Greensmaster® 1000 and 1600

Subject: Machine is hard to move without engine running.

Belt Guide Kit (95-0924) Instructions

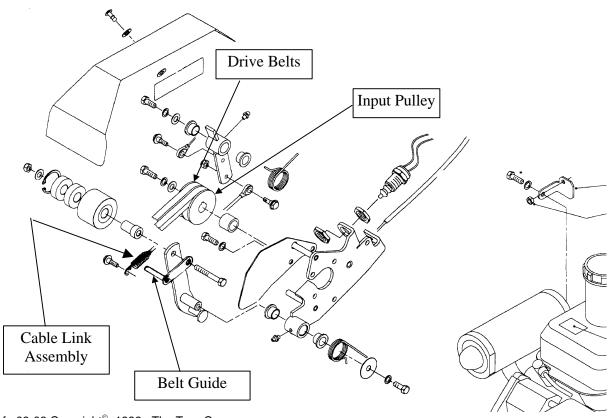
In the disengaged position, the traction belts do not fully disengage from the drive pulleys. This condition is normal but it does make it difficult to move the machine around the shop. The addition of a belt guide improves the belt disengagement and maneuverability with the engine off. Belt Guide Kit (95-0924) is available through your Toro distributor. Instructions are listed below.

This kit includes a new Belt Guide and Cable Link Assembly. The Belt Guide ensures the belt will fully release from the Input Pulley to improve manual handling of the machine. The Cable Link Assembly changes belt engagement characteristics to improved compensation for worn components.
